New Features

These new features will be in all new Element4 Fireplace models AND in MKII versions of current models noted below:

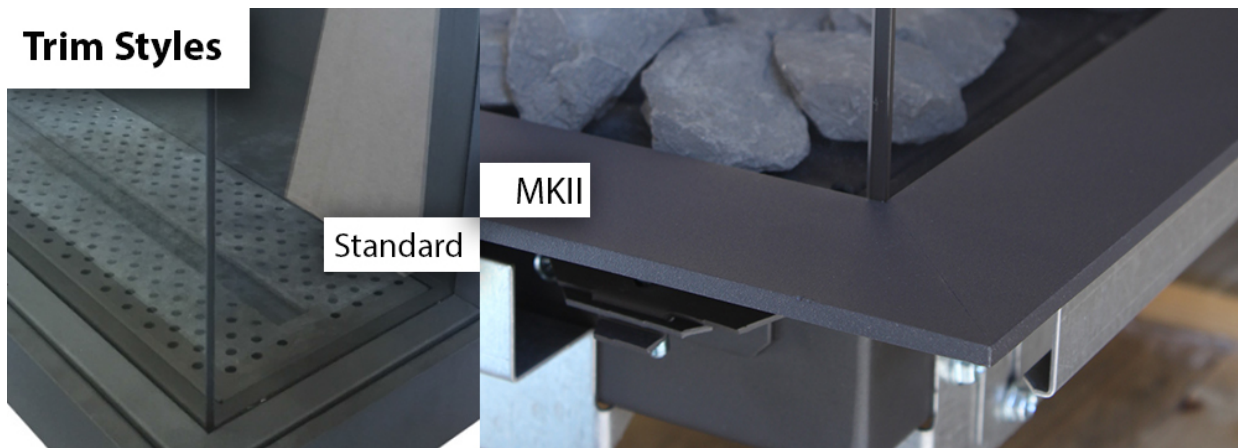
New Designer Trim

- One seamless piece solid heavy gauge bottom trim
- Allows for cleaner look at install, especially when surrounding fireplace with stone

Tube Burner

- All new fireplaces and MKII models will have tube style burners (similar to current 95 models)
- Lucius 140, Modore 140, Bidore 140, Trisore 140, Lucius 100 and Tenore 100 to have double tube burner
- Flame turndown between 53% - 71%
- Allows for more robust looking flame and improved performance at high altitudes
- Improved flame appearance when using LP gas
